Access Compliance Report

Public Rights-of-Way

Intersection ID: 9768	Main Street: EASTWAY_DR	Cross Street: THE_PLAZA	Location: SW
ADA ID: 74776DA02E8C	Ramp Type: PerpDiag	Initial Pass/Fail: Fail	Overall Compliance: No
Severity Score: 22.5			
Codes/Mitigation Info/Possible Solution		Field Measurements/Component Compliance

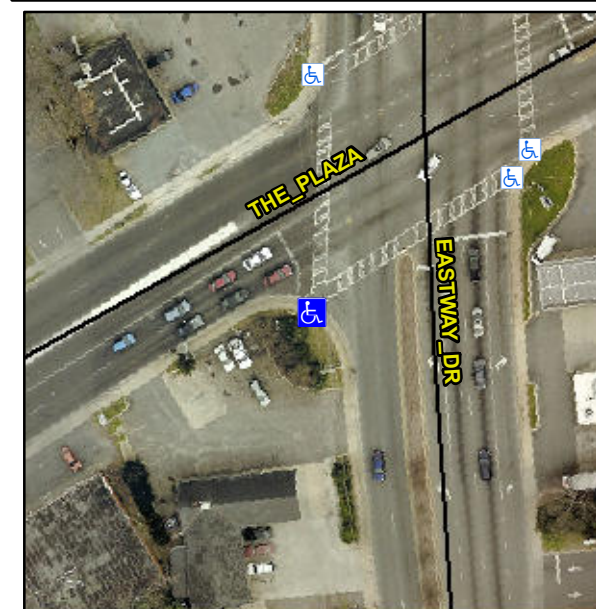
Not Found, R304.5.1, R304.2.2, R304.5.3

Compliance	Description	Data	Compliance	Description	Data
N/A	Ramp Length (in)	58.5	No	Ramp Slope (%)	11.1
No	Ramp Width (in)	46.5	No	Ramp XSlope (%)	4.5
N/A	Flare Type LT	N/A	N/A	Flare Type RT	N/A
N/A	Flare Slope LT (%)	N/A	N/A	Flare Slope RT (%)	N/A
N/A	Flare Traversable LT?	N/A	N/A	Flare Traversable RT?	N/A
N/A	Landing Length (in)	N/A	N/A	DWS Provided?	N/A
N/A	Landing Width (in)	N/A	N/A	DWS Contrast?	N/A
N/A	Landing Slope (%)	N/A	N/A	DWS Length (in)	N/A
N/A	Landing X Slope (%)	N/A	N/A	DWS Full Width?	N/A
N/A	Landing Curb? (Y/N)	N/A	N/A	DWS Offset (in)	N/A
N/A	Shared Landing?	N/A			
N/A	Gutter Ponding?	N/A	N/A	Gutter Slope (%)	N/A
N/A	Gutter Lip Ht (in)	N/A	N/A	Gutter X Slope (%)	N/A
N/A	Painted X Walk1?	Yes	N/A	Painted X Walk2?	Yes
	X Walk 1 Direction	To NE		X Walk 2 Direction	To N
N/A	X Walk 1 Width (in)	82.5	N/A	X Walk 2 Width (in)	80.0
	X Walk 1 Slope (%)	0.2		X Walk 2 Slope (%)	0.8
	X Walk 1 X Slope (%)	0.1		X Walk 2 X Slope (%)	2.1

Remove & Replace Curb Ramp With Two New Directional Ramps or Equivalent. Restripe Crosswalk.
